**ANN ARBOR HISTORIC DISTRICT COMMISSION**

**Staff Report**

**ADDRESS:** 1137 Traver Road, Application Number HDC19-236

**APPLICATION:** The applicant seeks HDC approval to selectively demolish and replace portions of the north, south, and east walls of the 2-story section of the house; reconstruct the north porch; and remove the non-historic stucco.

DRAWN BY: BLR  
ARCHITECT: BLR  
SHEET NUMBER:  
**A-200**

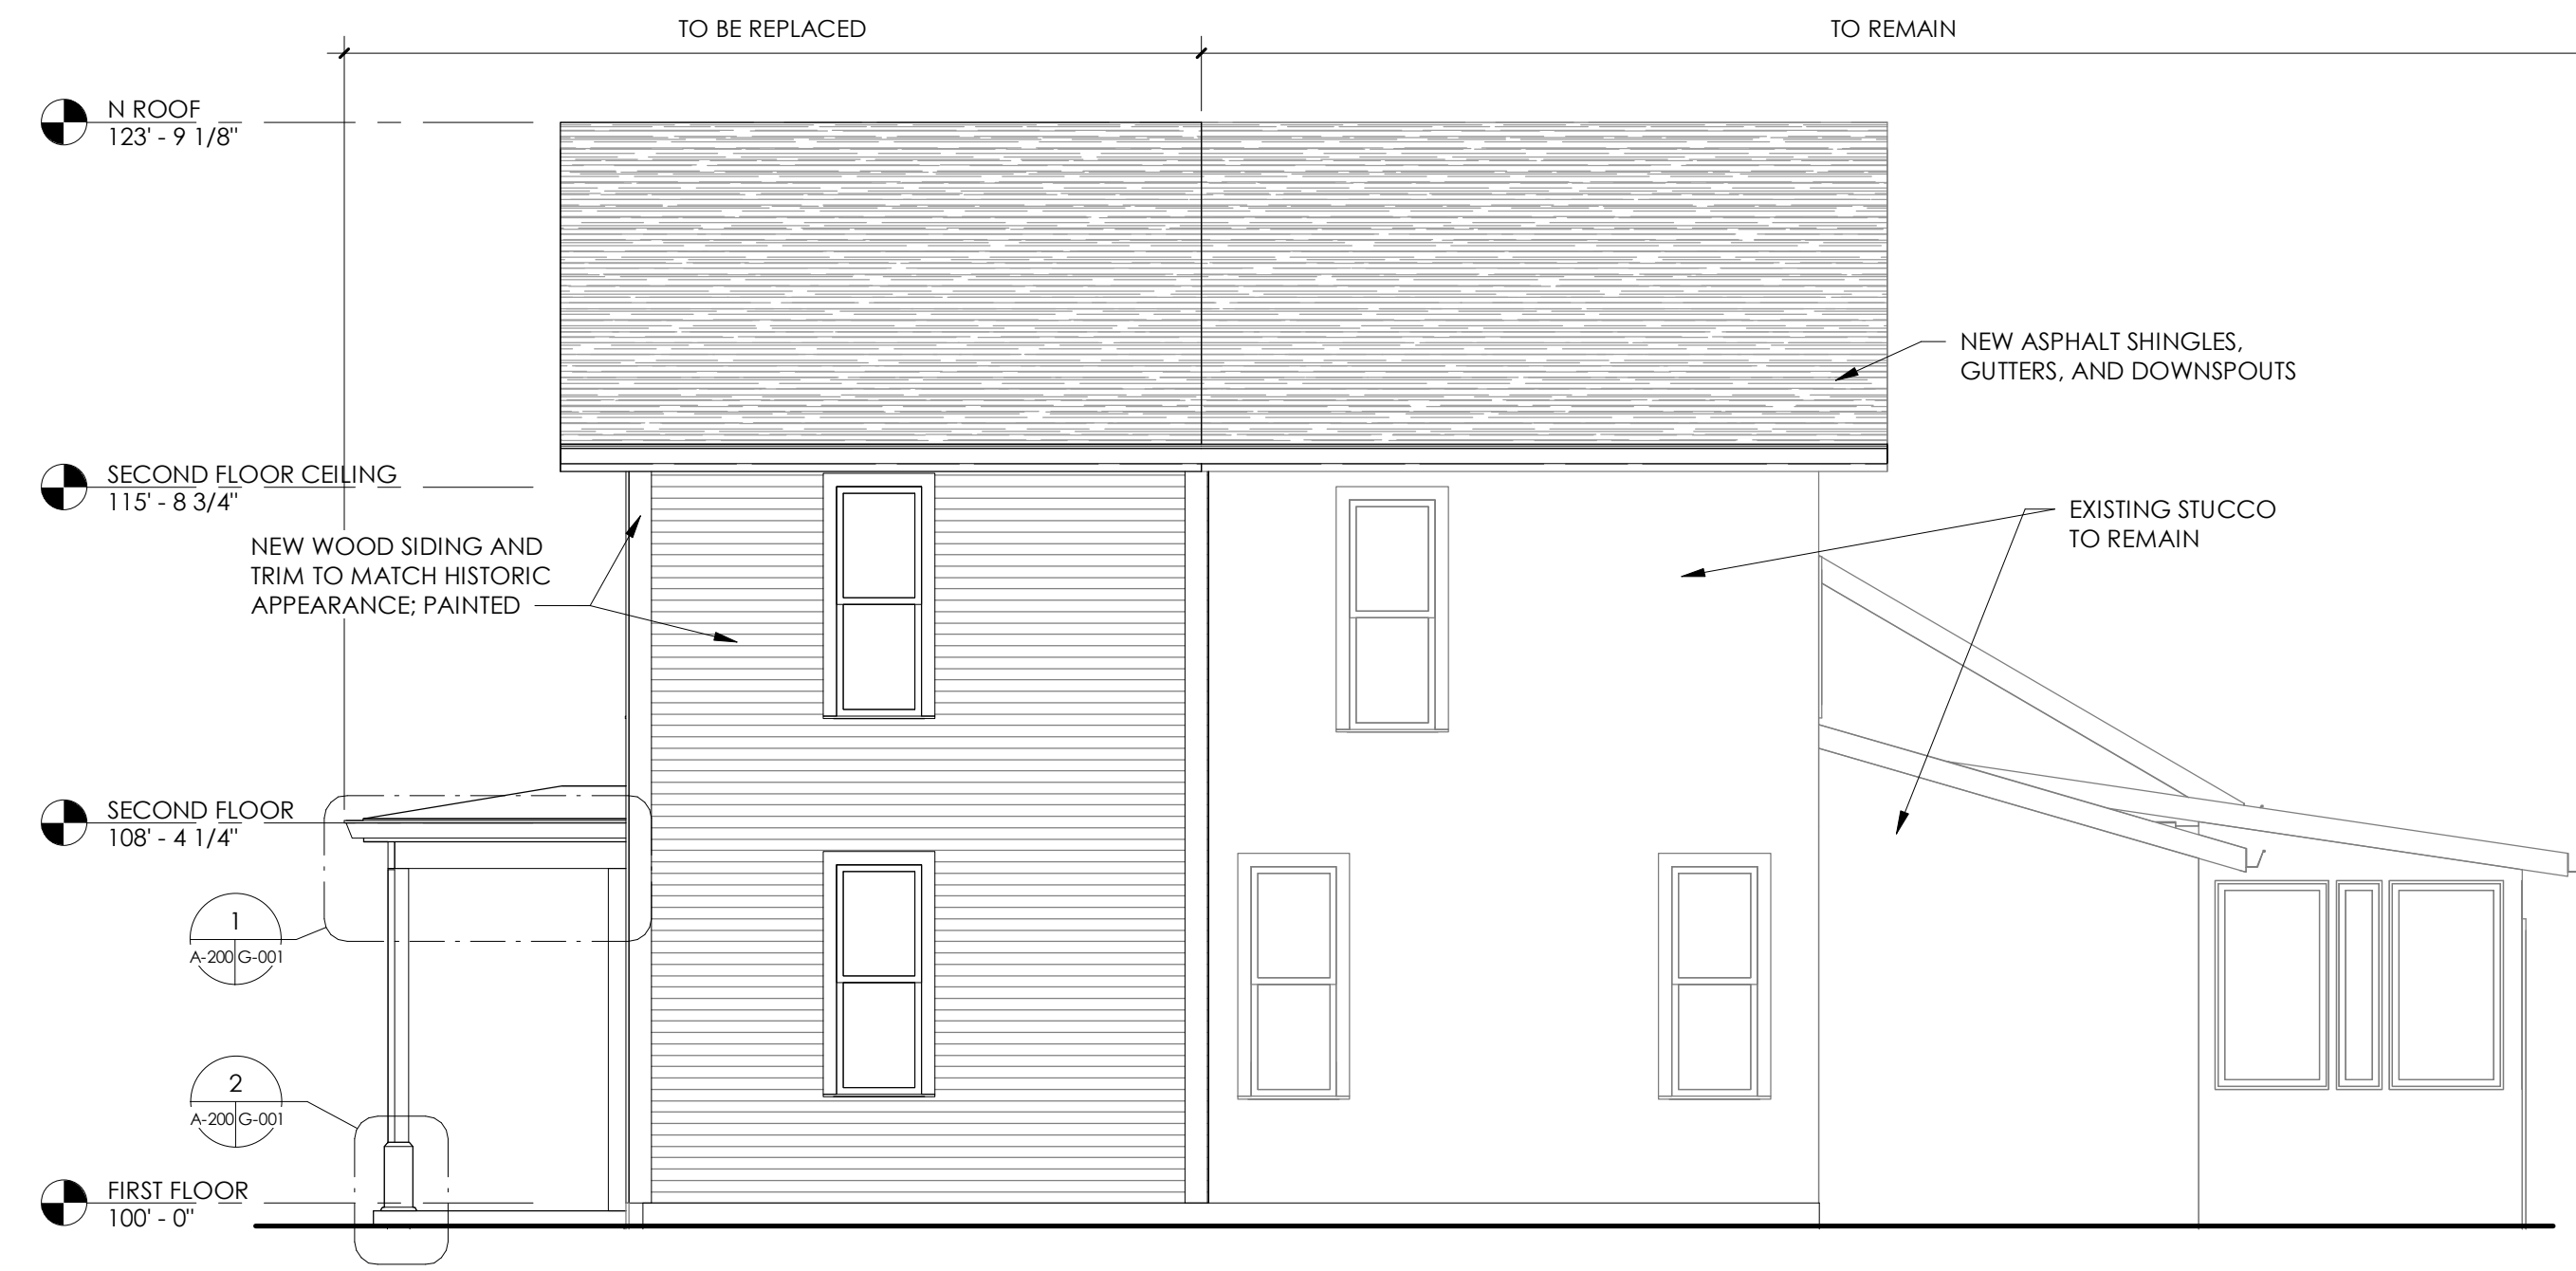
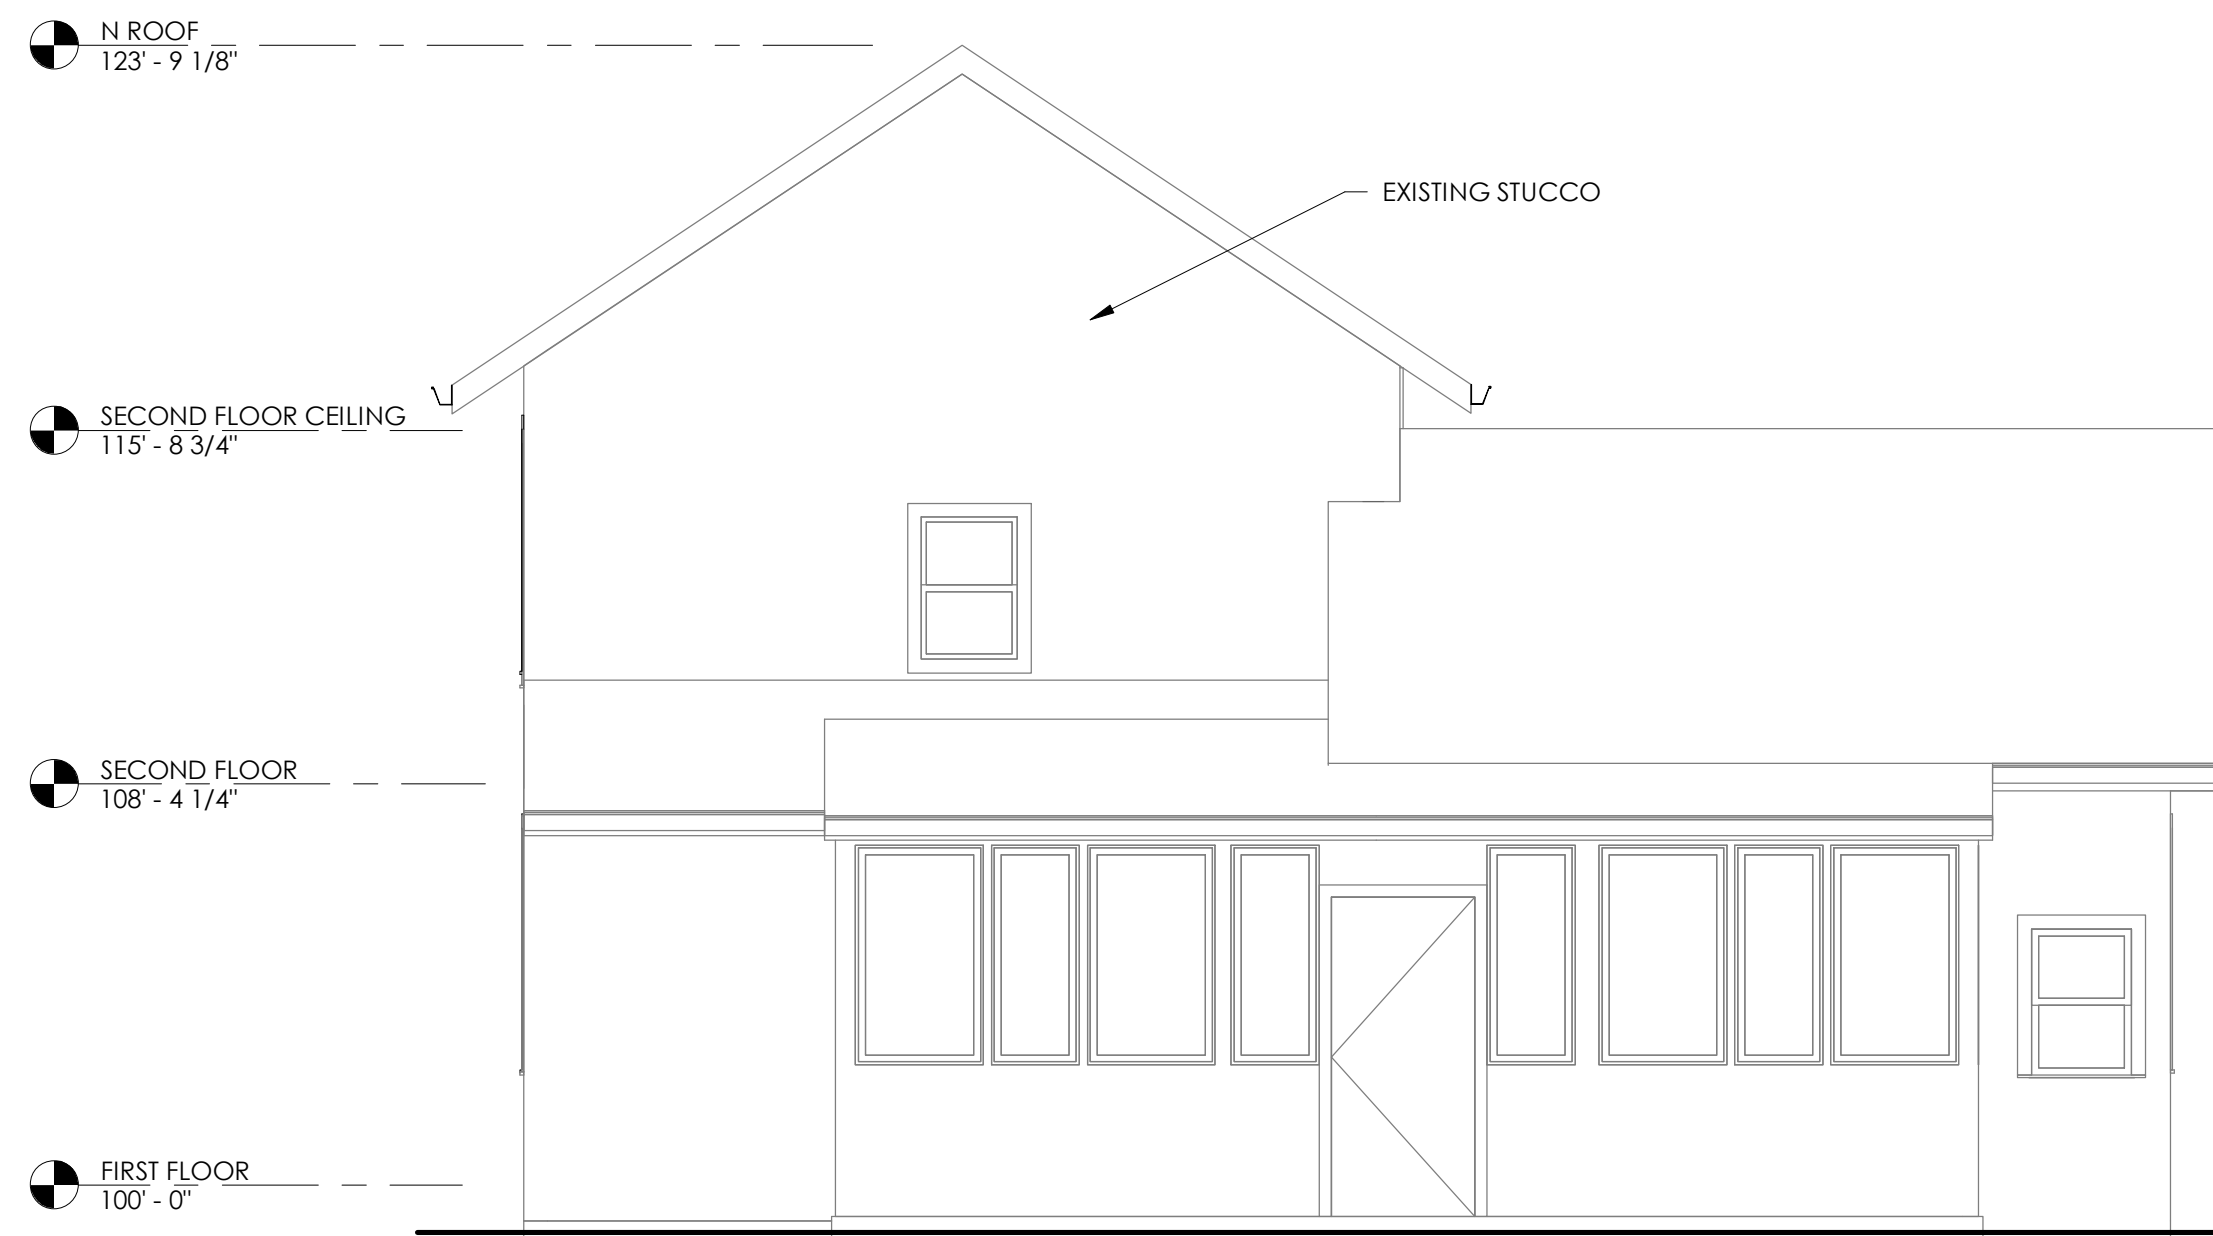
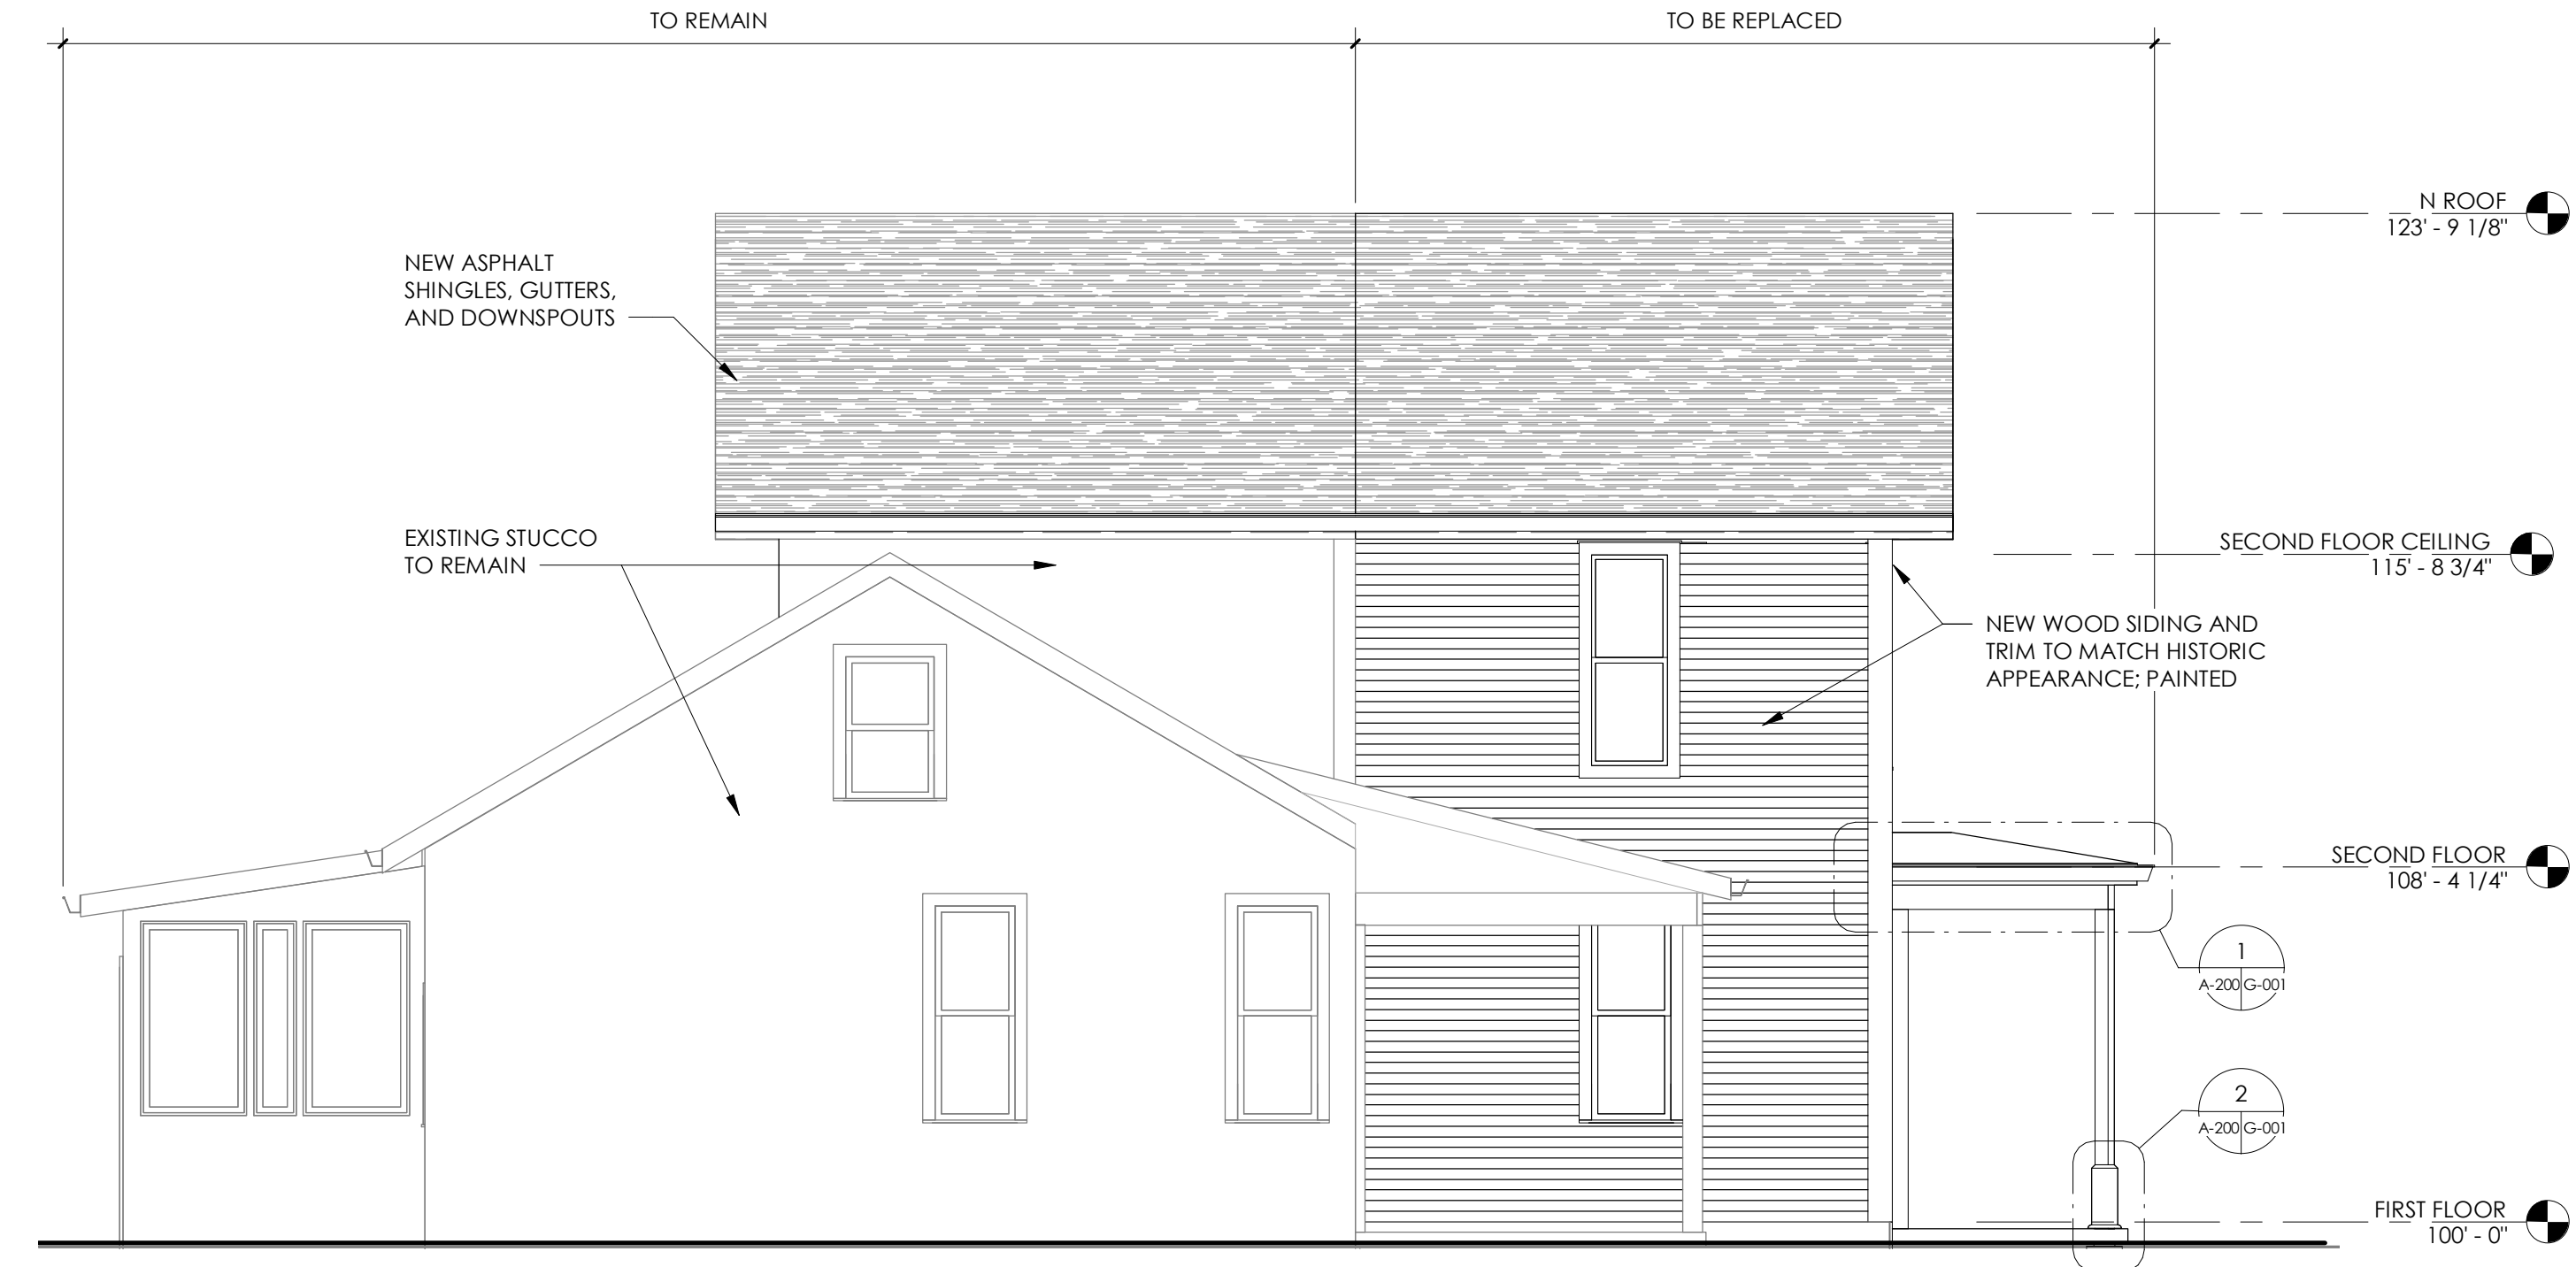
4. *Siding.* The reconstructed portion of the house is proposed to be wood lap sided to match the historic. The siding on both sides ends in the center of the façade, which seems visually abrupt on the drawings. Staff understands that this is an expensive project and the homeowner may wish to save the full siding replacement for a future expense, but the HDC will need to weigh whether this is appropriate.
